**INSTITUT BELGE DES SERVICES POSTAUX ET DES
TELECOMMUNICATIONS**

**DECISION DU CONSEIL DE L'IBPT
DU 12 DECEMBRE 2007
CONCERNANT
BROBA REACH EXTENDED ADSL2**

Addendum n°4 to the Belgacom Reference Offer for Bitstream Access

Reach Extended ADSL2

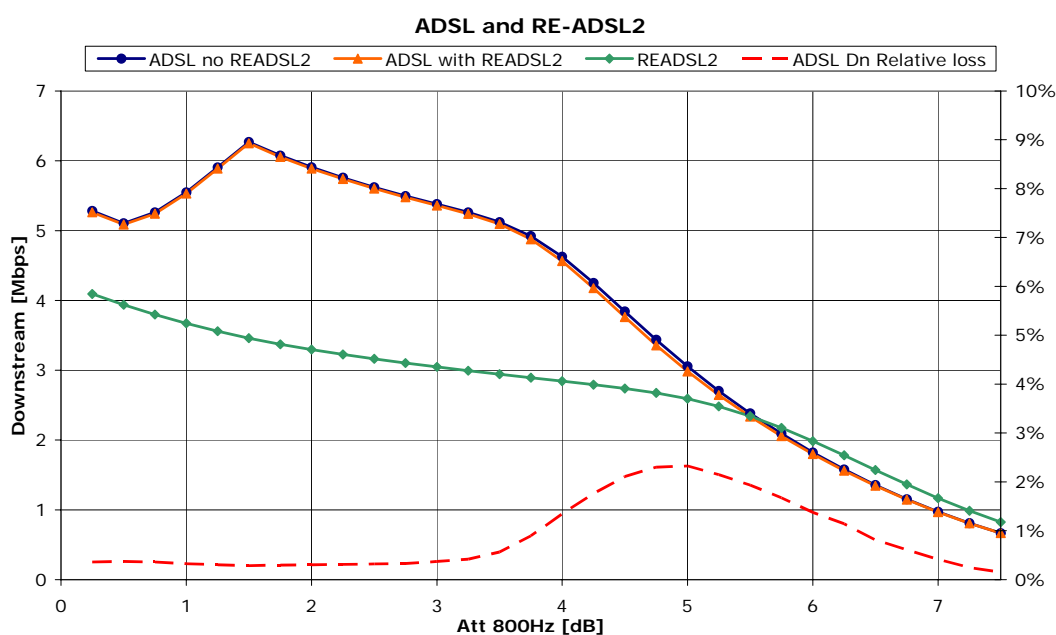
Mobistar, Scarlet & Versatel/Tele2 se posent des questions quant au choix de Belgacom dans le cas IIa, étant donné que la portée de BROBA ADSL diminuerait.

Belgacom n'est pas d'accord avec cela. Belgacom souligne que l'introduction de BROBA ADSL2 Reach Extended permet justement de connecter des utilisateurs finals qui n'avaient auparavant pas d'accès à l'Internet large bande, plutôt que de restreindre les possibilités de l'ADSL. Grâce à Reach Extended, Belgacom accroît sa responsabilité dans la couche

physique de 6,5dB à 7,5dB. Ce qui représente une augmentation de 15% de l'atténuation autorisée.

En ce qui concerne le cas IIa, Belgacom a décidé d'offrir le meilleur service au client. L'ADSL2 Reach Extended a une meilleure performance au-dessus de 5,5 dB. Il n'y a qu'une différence de 0,25dB entre l'atténuation minimale et maximale, donc l'ADSL2 Reach Extended n'apparaîtra qu'à partir de 6,25 dB, où la qualité du Reach Extended est clairement supérieure à l'ADSL.

Belgacom fait remarquer enfin que l'intérêt du cas IIa doit être considéré dans la bonne perspective. En supposant que la différence moyenne entre l'atténuation minimale et maximale est de 0,25dB, cela n'aura d'influence que sur un pourcentage marginal de 0,2% de la population. Belgacom ne voit pas pourquoi ce pourcentage est significatif pour les OLO.

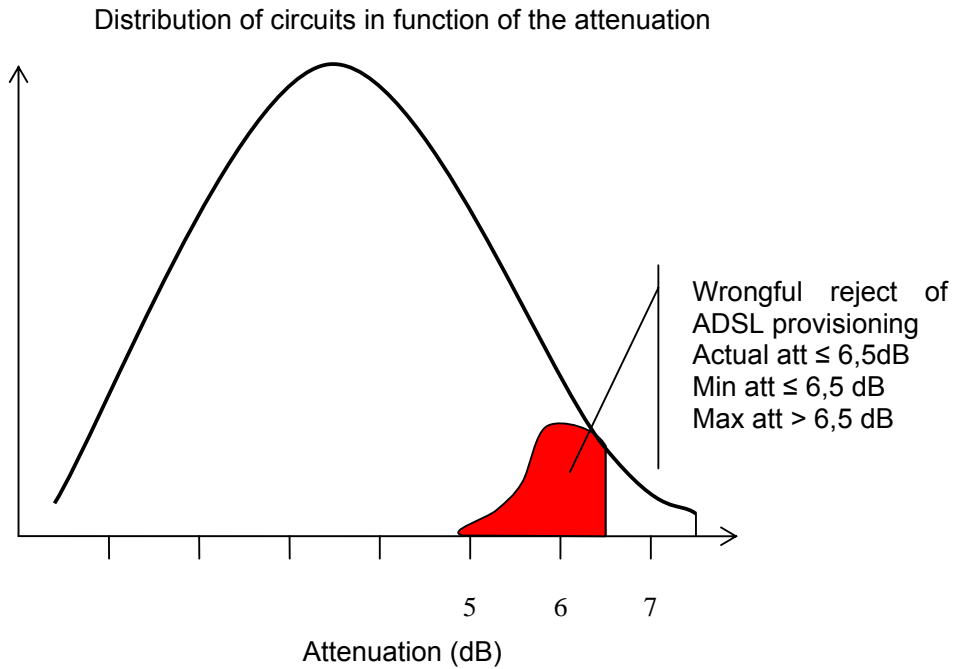
Mobistar, Tele2-Versatel & Scarlet ne sont pas d'accord avec le raisonnement de Belgacom. L'impact ne peut pas être calculé sur la base de la couverture de la population entre 6,5dB et 7,5dB étant donné que la perte de la couverture ADSL n'intervient que pour les lignes où l'atténuation réelle reste en dessous de 6,5dB. De plus, seul l'espacement moyen entre les circuits est pertinent dans le cas IIa et pas uniquement l'espacement entre leur dernier segment, par conséquent, l'espacement entre min. et max. est probablement supérieur à 0,25dB.

Etant donné que la distribution des circuits en fonction de l'atténuation n'est généralement pas plane et que l'espacement est probablement supérieur à 0,25dB, les suppositions de Belgacom constitueront sans doute une sérieuse sous-estimation de la diminution de la couverture ADSL comme le montre leur schéma suivant (pour raisonnement voir appendix 1).

Sur cette base, Mobistar, Tele2-Versatel & Scarlet demandent d'examiner plus en profondeur la diminution de la couverture. Dans le cas IIa, une étude technique complémentaire devrait en tout cas avoir lieu pour voir si la fourniture via ADSL est possible ou non.

ANNEXE 1 : REDUCTION COUVERTURE ADSL

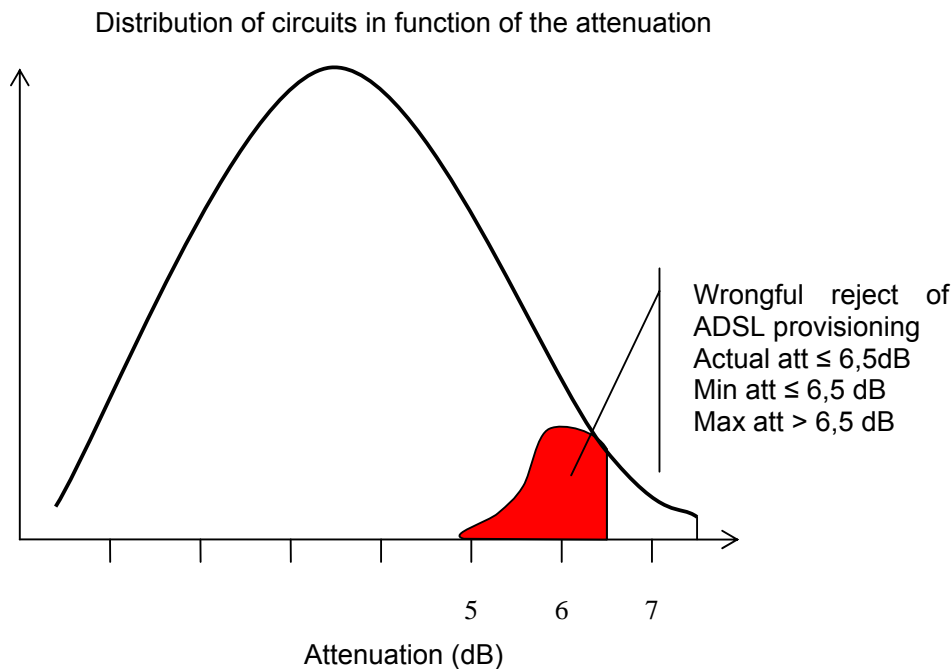
In order to assess this reduction of the population reached by ADSL only more precisely, one must quantify the cases where ADSL is wrongfully rejected i.e. where the actual attenuation $\leq 6,5$ dB in case IIa.

Hereby one assumes within a segment an equal distribution, i.e. the actual attenuation for a given min – max attenuation pair is equally distributed between both values. This is a conservative assumption as the farer on gets from the city centre and thus the LEX, the less dense the population gets.

This reduction may well be substantially larger than the 0,2% indicated by Belgacom as the figure below indicates.
